ARCHITECTURAL CASEWORK
SHOP DRAWING SUBMITTAL

Section 06 41 00 Architectural Wood Casework

PROJECT
SAMPLE HOTEL LOBBY
Public-space casework (sample job)

ITEM
CW-1 to CW-3
Reception desk (CW-1), breakfast kitchen wall (CW-2), fitness hydration counter (CW-3)

6 UNDER-COUNTER REFRIGERATOR OPENING

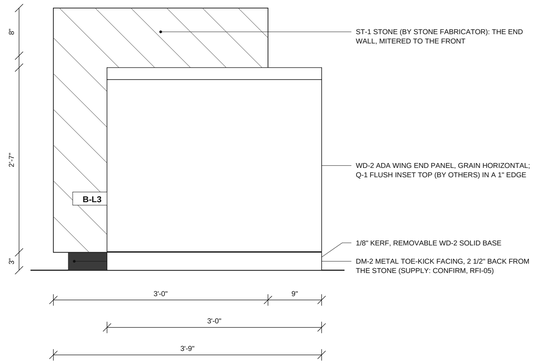
- C-AP1: Under-counter refrigerator opening: the 2'-9" refrigerator on a 1" base by the GC (2'-10") does not fit the 2'-9 1/2" clear height under the 2CM quartz top and its 3/4" sub-top (2" apron): 1/2" short. Refrigerator per cut sheet, verify (EQ-1, RFI-08).
- D-AP1: Under-counter refrigerator opening: the refrigerator is 2'-0" deep; the opening is 1'-5 1/16" to the door faces, so it projects 6 15/16" past the fronts. Refrigerator per cut sheet, verify (RFI-18, RFI-19, RFI-20).

Tags: C-AP1
2'-9 1/2" clear H x 2'-7 15/16" + 2'-7 15/16" clear W, 2'-6 1/16" D
Refrigerator per cut sheet, verify (EQ-1, RFI-08)

3 TOP EDGE AND TAB PULL (COORDINATION - BY COUNTERTOP FABRICATOR)

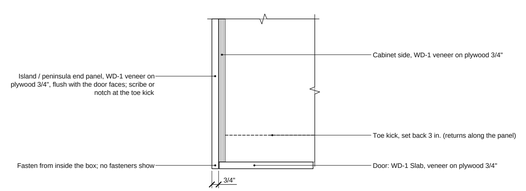
- B-B1: Tab pulls under the countertop overhang (B-B1, B-B3): 1/4" reveal, the tab reaches 1/2" past the countertop edge: grip from below; confirm the pull.

- D-B1: Tab pulls under the countertop overhang (D-B1, D-B3): 1/4" reveal, the tab reaches 1/2" past the countertop edge: grip from below; confirm the pull.

2 WALL SECTION: AT THE REFRIGERATOR OPENING (LOOKING WEST)

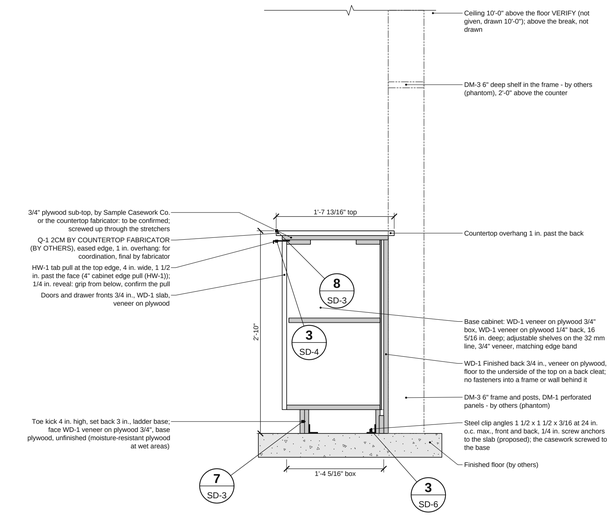
- C-AP1: Countertop support: the 2CM quartz spans 2'-7 15/16" over the refrigerator opening (over about 2'-0"): add an intermediate support panel or leg, or confirm the span with the countertop fabricator.

At C-AP1 (cut marks on the plan and elevations)
